Item Name: Replacement Skidtube (Fits LH or RH)

DRAWING NO. D2650	TITLE 206/407 SKIDTUBE ASSEMBLIES	REV. F	DART AEROSPACE LTD ENGINEERING ORDER		D.E.O. NO. D2650-F-1	SHEET NO. SHEET 1 OF 1	SCALE NTS
DRAWN <i>JP</i>	CHECKED <i>A.P.</i>	MFG. APPR. <i>DA</i>	APPROVED <i>#</i>		DE APPR. <i>#</i>		
DATE 12.10.12	DATE 12.10.22	DATE 12.10.22	DATE 12.10.22		DATE 12.10.22

CHANGE C'BORED WELDED CROSSBOLT SPACERS TO SWAGED SPACERS

DETAIL G

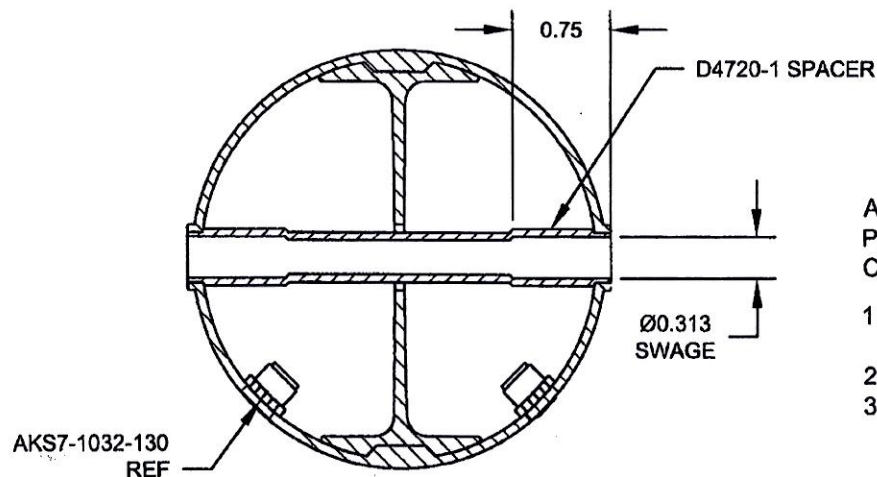
17	18	19	23	D2649	CROSS BOLT SPACER
----	----	----	----	-------	-------------------

ADD DETAIL G BELOW, WHICH IS THE SAME SECTION VIEW AS DETAIL D OF DWG.
C'BORED HOLES ARE **NOW SWAGED** PER DETAIL G BELOW. FOR THE Ø0.375 HOLE THAT IS NOT C'BORED, WELD PER DETAIL D OF DWG (SEE AMENDED DETAIL B FOR REFERENCE).

D2649 SPACER,
WELD PER DETAIL D OF DWG
BUT DO NOT C'BORE

AMENDMENT TO DETAIL B
NOT TO SCALE
